CALIFORNIA COASTAL COMMISSION

ITEM: WED 18e**Filed: 10/01/98****49th Day: 11/19/98****180th Day: 3/30/99****Staff: MH-V *[Signature]*****Staff Report: 10/05/98****STAFF REPORT: REGULAR CALENDAR****APPLICATION: 4-98-194****APPLICANTS: Dick and Diane Sittig AGENT: Lynn Heacox,
The Land & Water Co.****PROJECT LOCATION: 6763 Zumirez Drive, City of Malibu, Los Angeles County****LOCAL APPROVALS: City of Malibu, Approval in Concept, August 28, 1998**

PROJECT DESCRIPTION: Demolish existing 1,700 sq. ft., one-story, single family residence and construct new 6,033 sq. ft., two-story, 26 ft.9 in.-above finished grade single family residence, retain existing 494-sq. ft. detached garage, construct 750 sq. ft. swimming pool, 2,854 sq. ft. pool deck, 5,548 sq. ft. sunken tennis court, install new 1,500 gallon septic tank and 3 seepage pits, conduct 761 cu.yds. of grading (all cut), and remove 5 mature, non-native trees, on a 1.49—acre lot.

EXHIBIT NO. A
APPLICATION (NO. 17-112)
setbacks/buffers

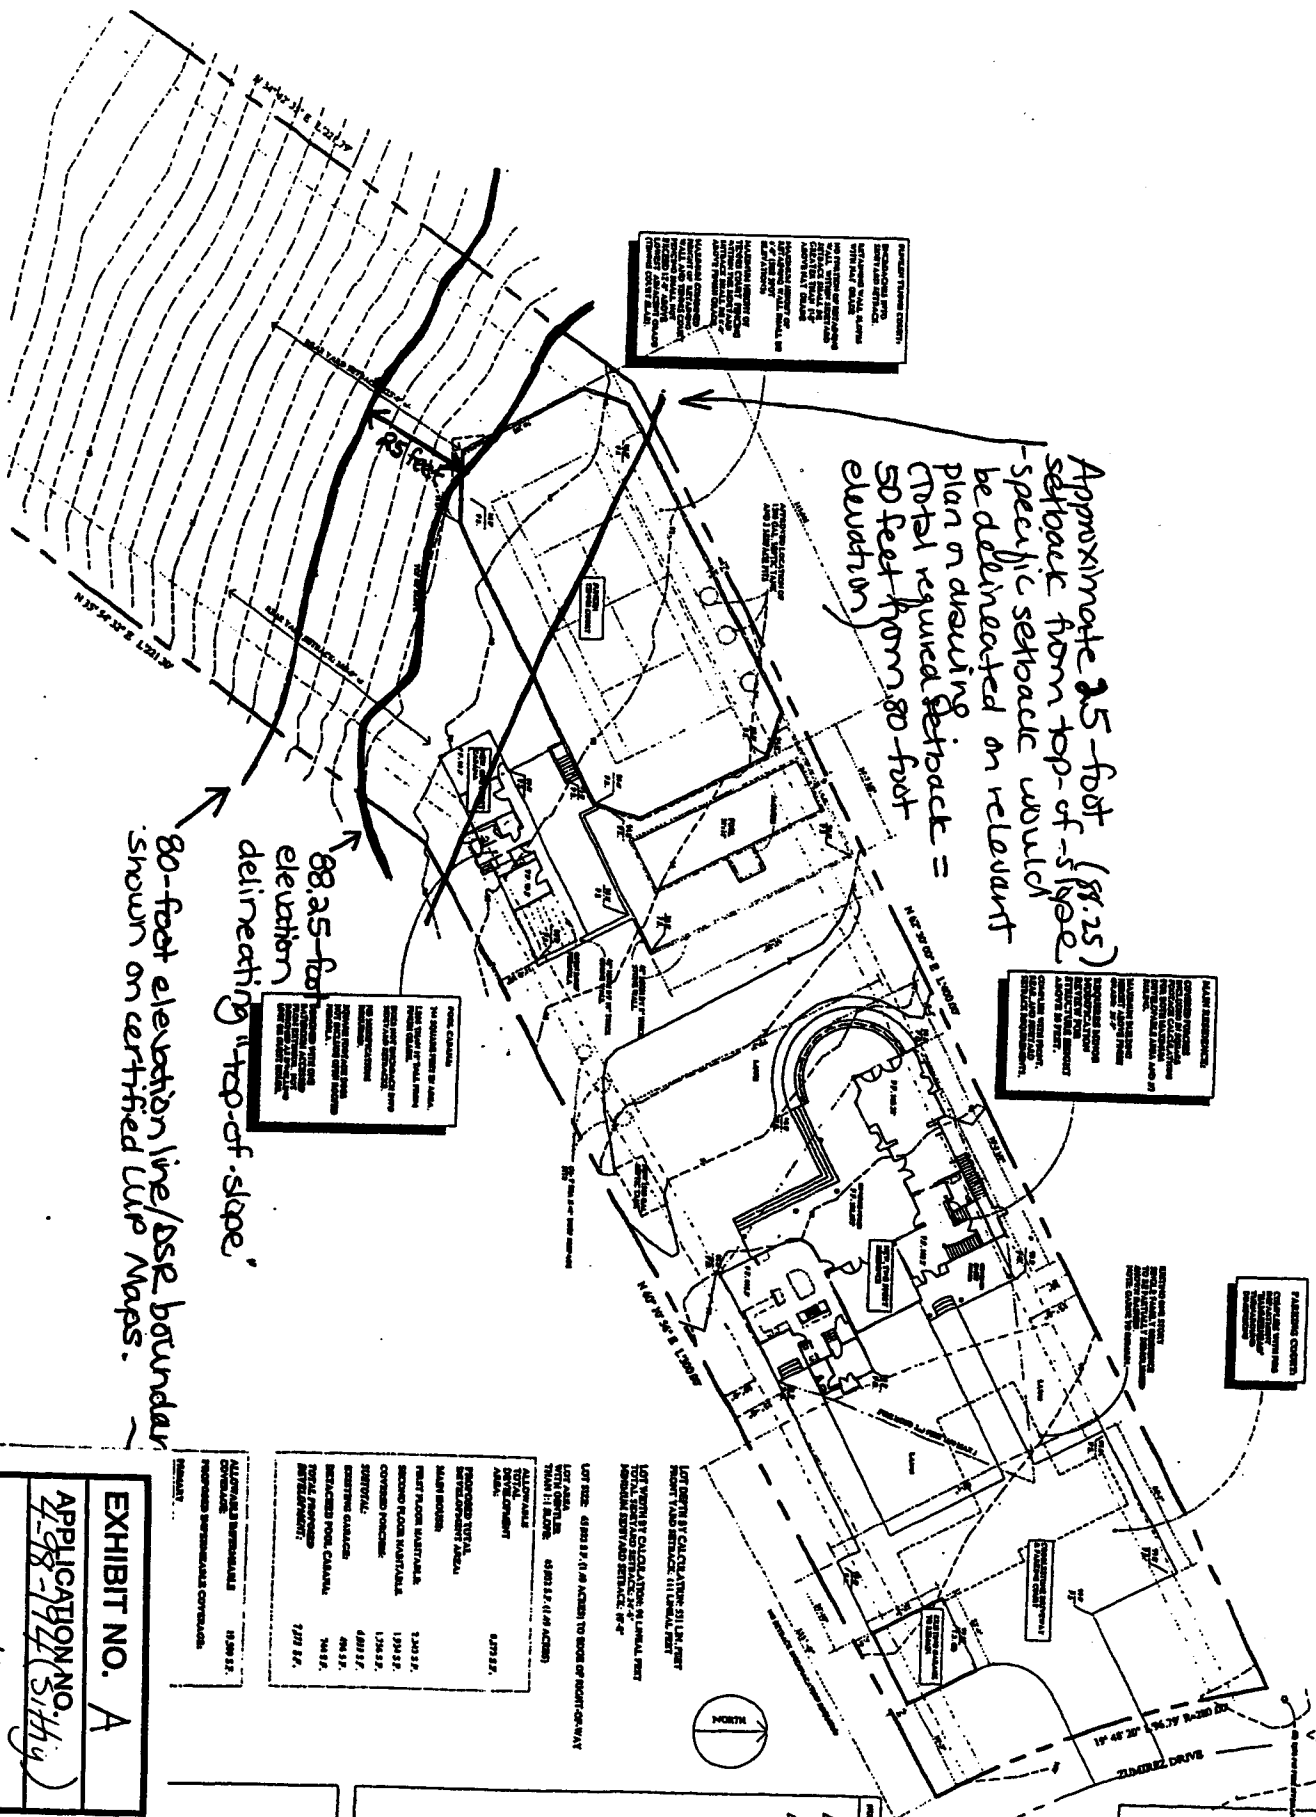
Approximate 25-foot (89.25) setback from top-of-slope
 - specific setback would be delineated on relevant plan or drawing
 Total required Setback = 50 feet from 80-foot elevation

80-foot elevation line/BSR boundary shown on certified UWP Maps.
 'delineating "top-of-slope" elevation

- (e) No irrigation shall be allowed in the buffer zone established between the 88.25-foot elevation line and the area up to a line drawn 25 feet upslope of the 88.25-foot elevation line, as generally shown on Exhibit A.

Special Condition 1 prohibits fuel modification below the 88.25-foot topographic elevation line shown on Attachment A and on Exhibits 4 and 5. The 88.25-foot line delineates the top of the slope descending into Walnut Canyon, and is located 25 feet upslope and toward Zumirez Drive from the approximate boundary (80-foot elevation) of the mapped DSR. This condition ensures that a 25-foot buffer from the DSR is maintained, thereby limiting erosional effects from the alteration of vegetation. The proposed residence, the only proposed habitable structure presently proposed by the applicant, is set back over 200 feet from the boundary of authorized fuel modification. Thus, modification of vegetation consistent with the Los Angeles County Fire Department's most stringent 200-foot radius standard can be undertaken without violating the requirements of the condition.

EXHIBIT NO. 4
APPLICATION NO.
4-94-198 (5th.g)
Site Plan

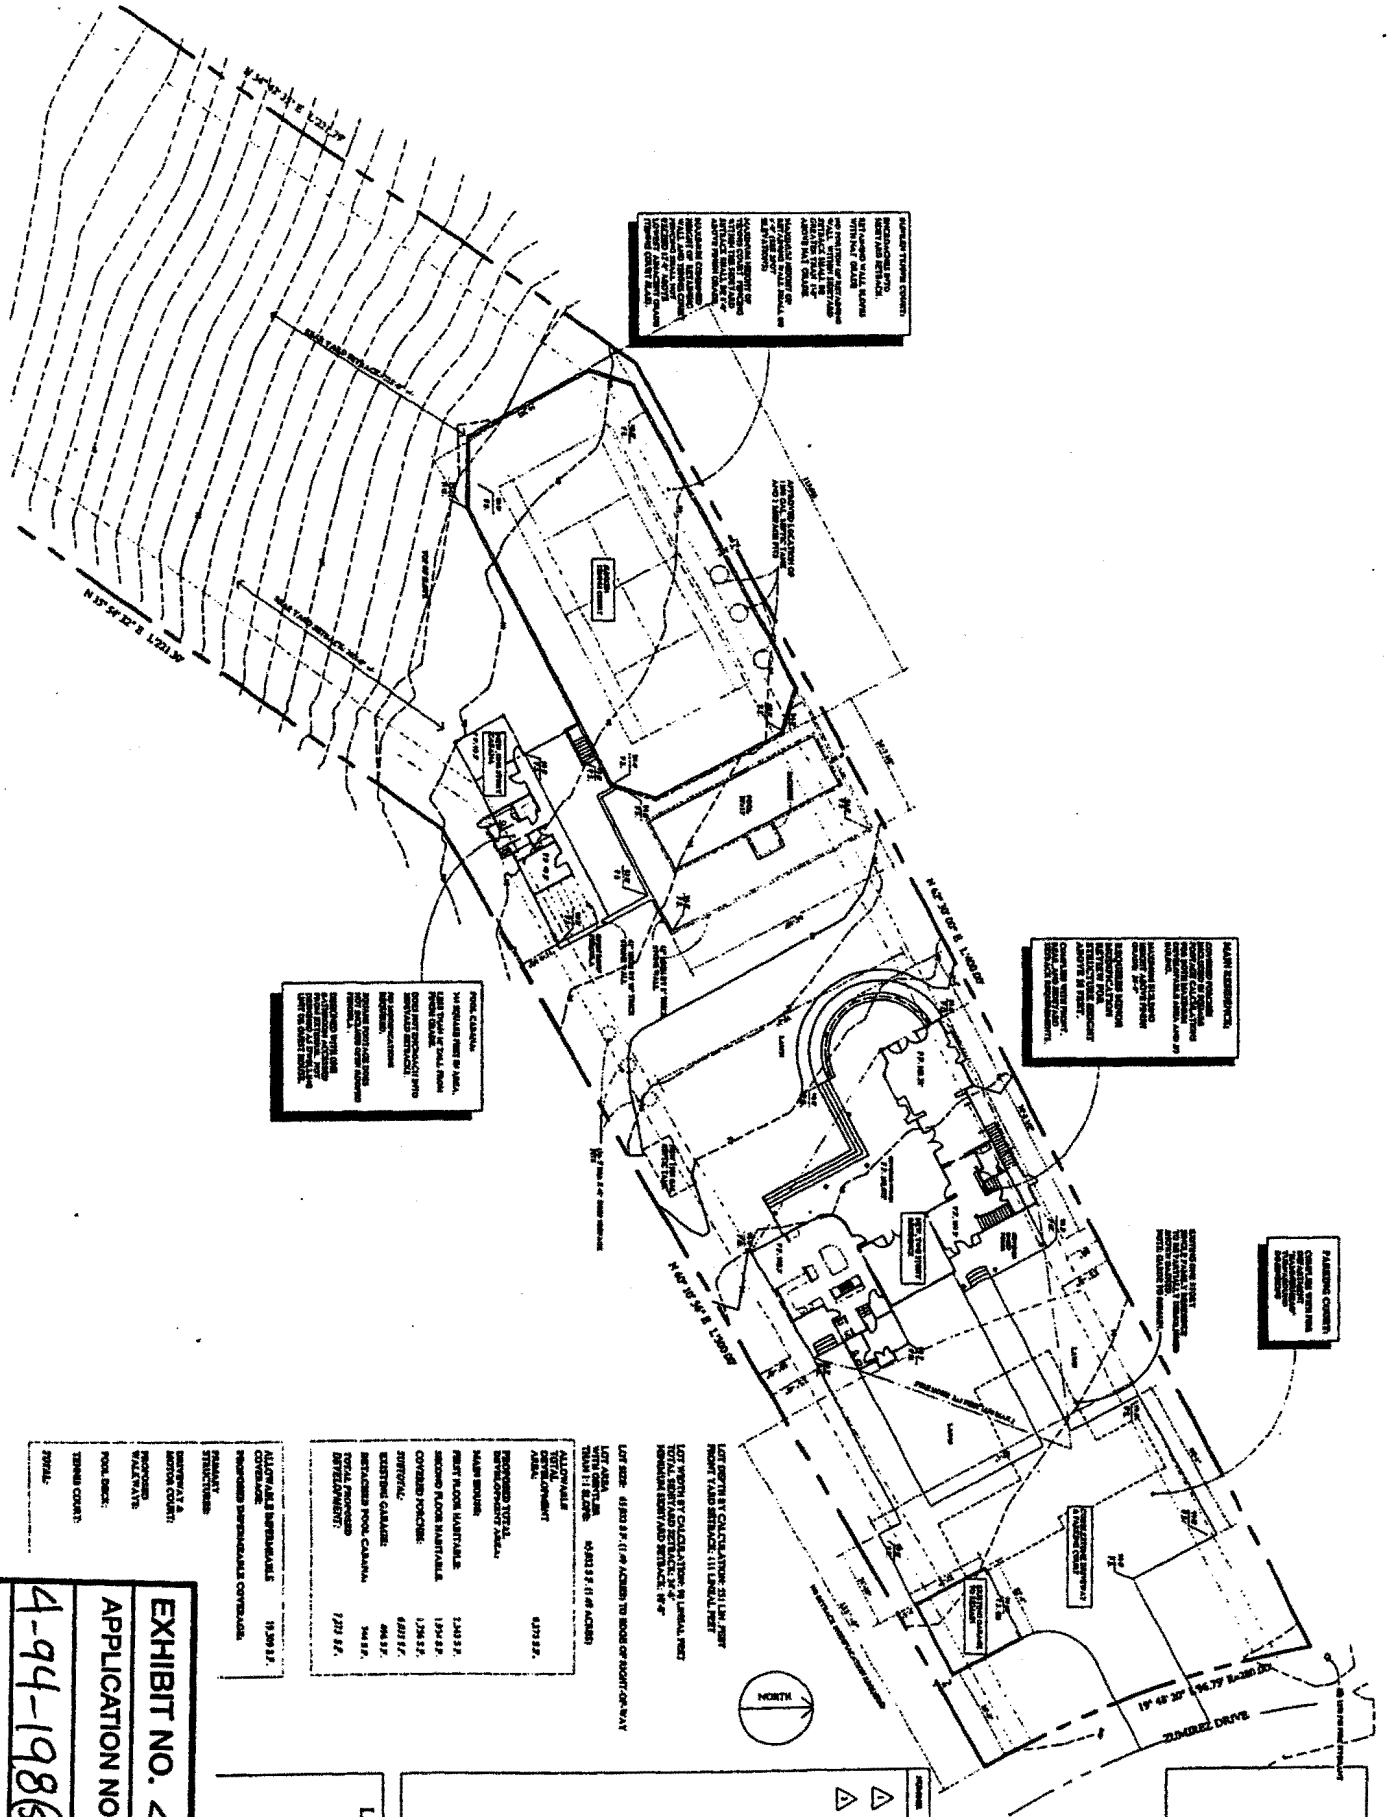
Special Condition 8 requires an additional 25-foot setback of the proposed tennis court from the location shown on the applicants' site plan (Exhibits 4 and 5). The setback will be required to be 25 feet further upslope (northeasterly), toward Zumirez Drive, from the 88.25-foot top-of-slope elevation line shown on Exhibits 4 and 5. The additional setback ensures that grading, excavation, and construction equipment staging will not take place at the slope's edge. Such activities increase the potential for overcasting of graded spoils down the flanks of the adjacent slope, compaction of slope edges, and trampling and destruction of vegetation at the slopes edge that would otherwise inhibit erosion and enhance gross slope stability. The required setback will provide a necessary buffer (a minimum of 50 feet between the development area and the mapped boundary of the adjacent sensitive resource area) between the construction activities and associated impacts and the sensitive habitat areas of the canyon slope and stream corridor. Therefore, adverse impacts that construction near the top of the slope may otherwise cause would be minimized or avoided.

In addition, as noted previously, the site plans on file at the time of report preparation still show a cabana located approximately 16 feet from the top-of-slope, adjacent to the proposed tennis court. The applicants' agent has verbally informed Commission staff that, under protest, but in response to concerns raised by staff regarding potential fuel modification of downslope vegetation that could be required by the L.A. County Fire Department for the cabana, the cabana has been deleted from the proposed project description. The deletion of the cabana will be verified in the revised plans required by **Special Condition 8**.

Prior to issuance of the coastal development permit, the applicant shall submit a revised project plan subject to the review and approval of the Executive Director, which illustrates that all portions of the proposed tennis court are setback a minimum of 25 feet from (northeasterly, or above) the 88.25-foot topographic elevation contour line delineating the top of the slope, toward Zumirez Drive, as shown on Exhibit A. The project plans shall also be revised to delete the previously proposed cabana shown in Exhibit 4 pursuant to the verbally-transmitted project revision of the applicants' agent on behalf of the applicants.

EXHIBIT NO. 5

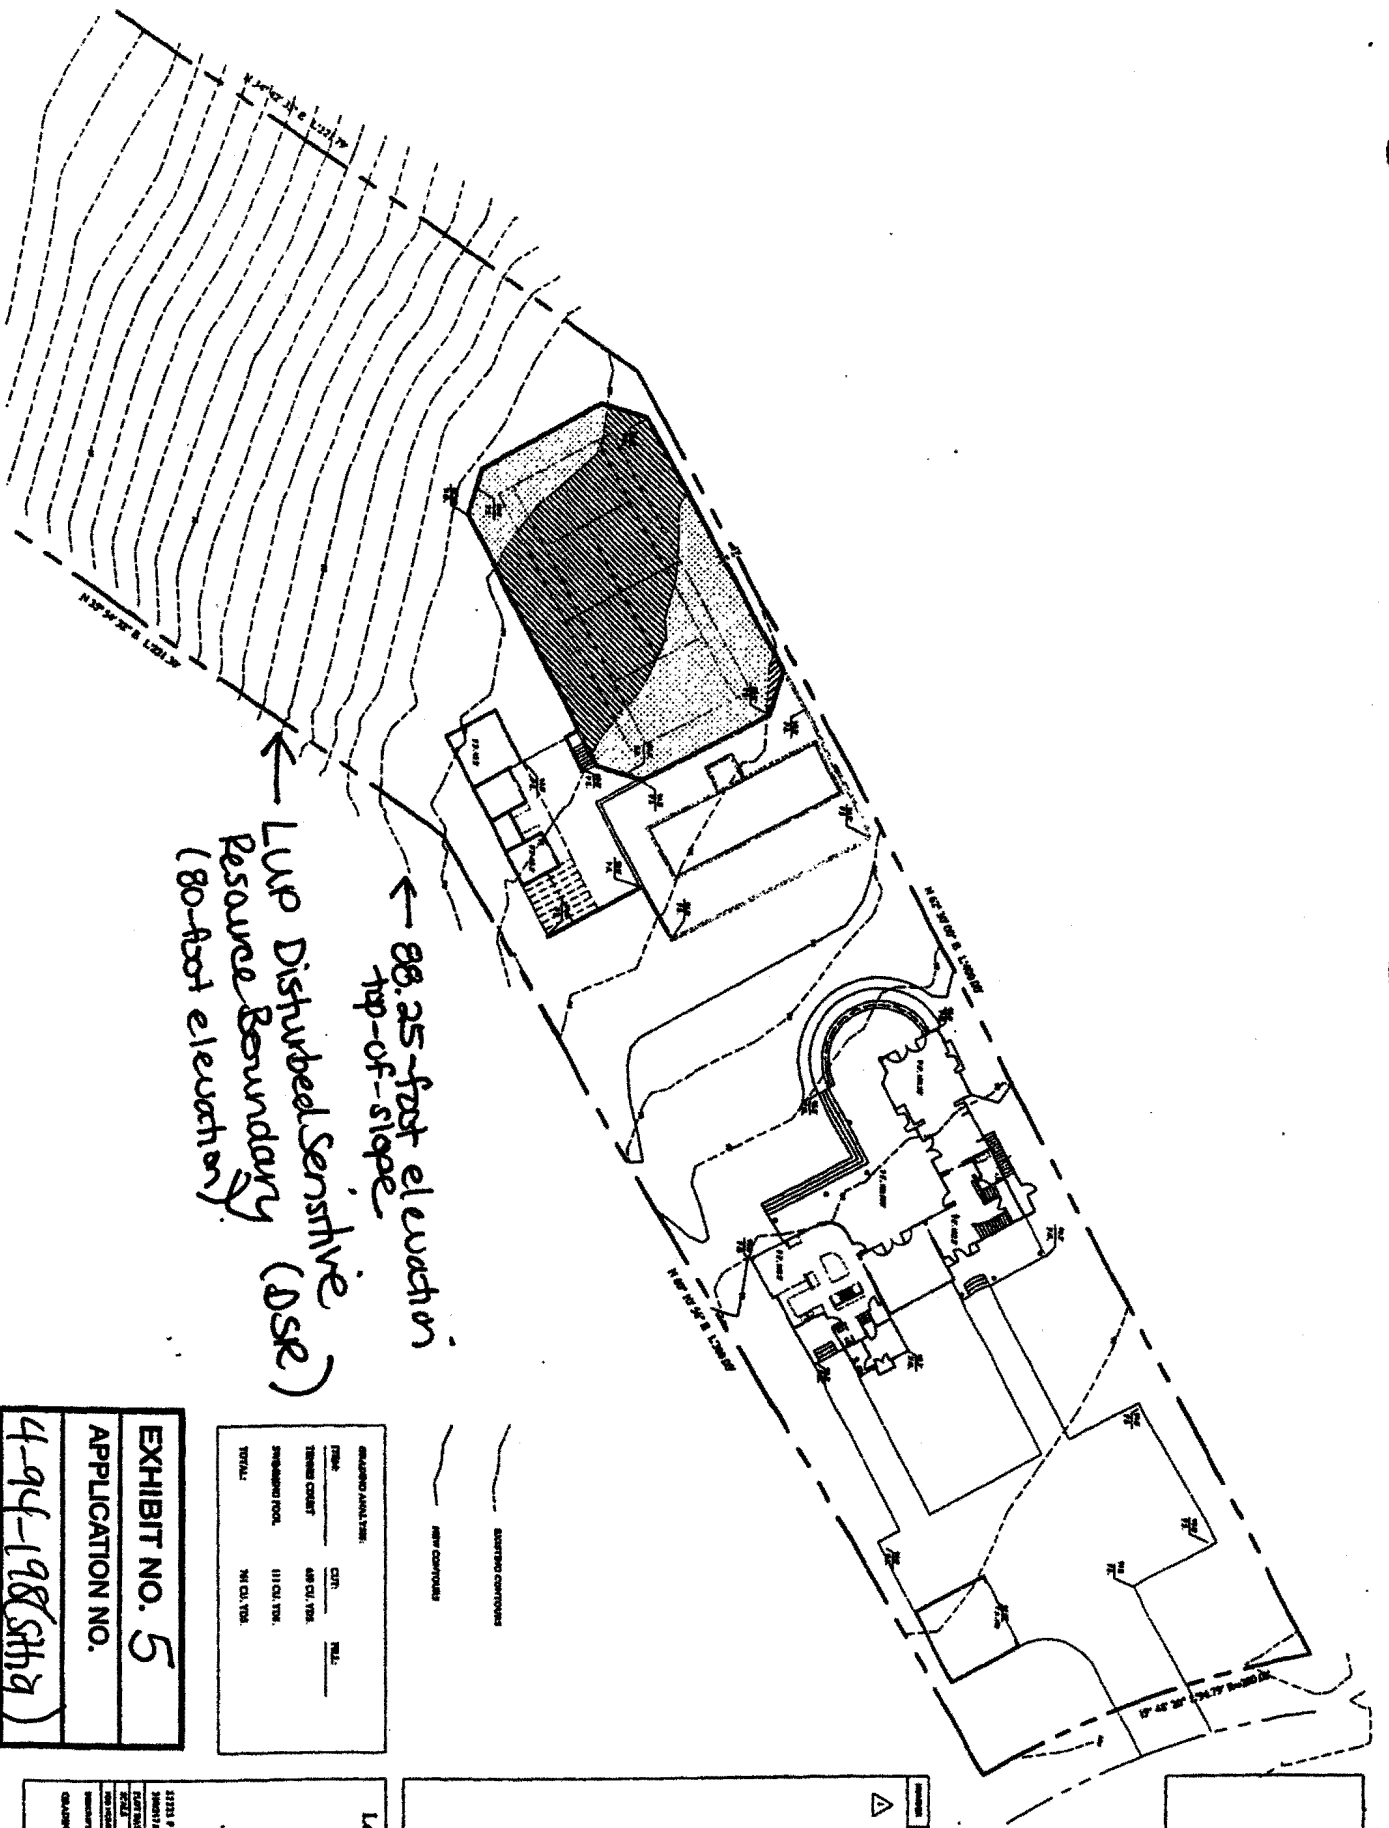
← 88.25-foot elevation top-of-slope

← LUP Disturbed Sensitive Resource Boundary (DSR) (80-foot elevation)
